ANALYSIS

Project Name: PUMPBACK AT THOUSAND SPRINGS – PHASE 1

Project Sponsor(s):

North Snake Groundwater District, Magic Valley Groundwater District, Clear Springs Foods, North Side Canal Company (NSCC)

Hydrographs

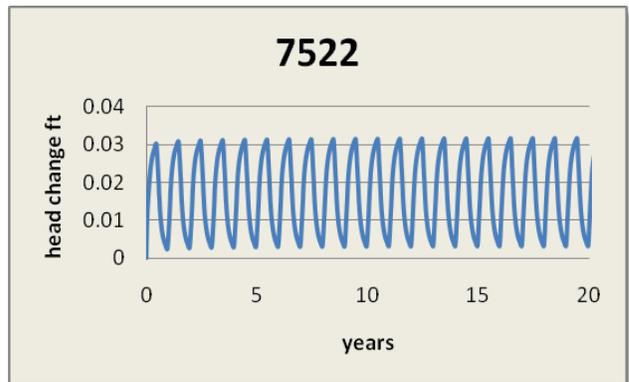
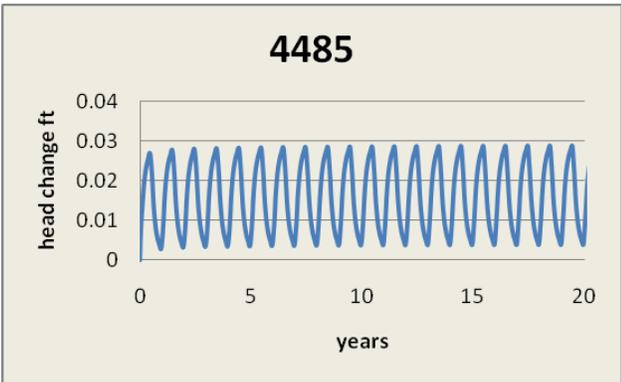
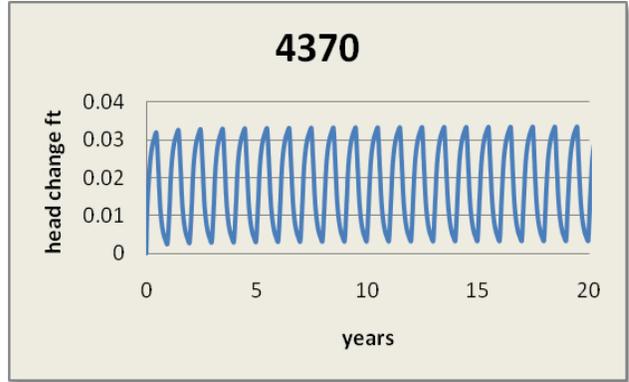
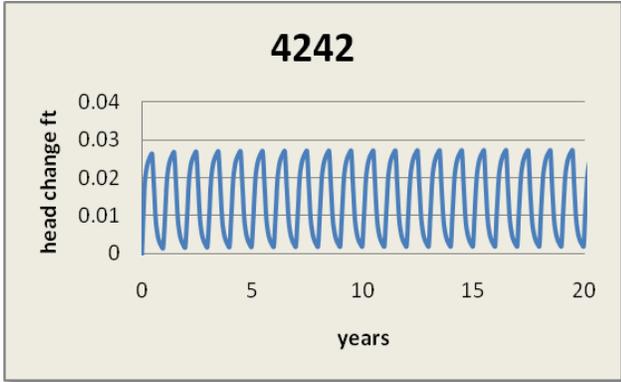
through the J8 Pond. It assumes a full supply of surface water is available for irrigation of the proposed acres. The modeled steady state analysis indicates 49% and 26% of the reduced pumping will return to the Buhl to Thousand Springs and Devils Washbowl to Buhl reaches respectively. Most of the water is expected to return within six months. Evaluation of the transient response over twenty years of operation indicates flows may increase up to 0.9 cfs and average 365 acre-feet per year in the Buhl to Thousand Springs reach, and flows may increase up to 0.4 cfs and average 185 acre-feet per year in the Devils Washbowl to Buhl reach. Modeled hydrographs of four monitoring wells in the vicinity of the targeted 920 acre conversion project demonstrate a water level rise of approximately 0.024 to 0.034 feet over a twenty year period (see Hydrologic Analysis below).
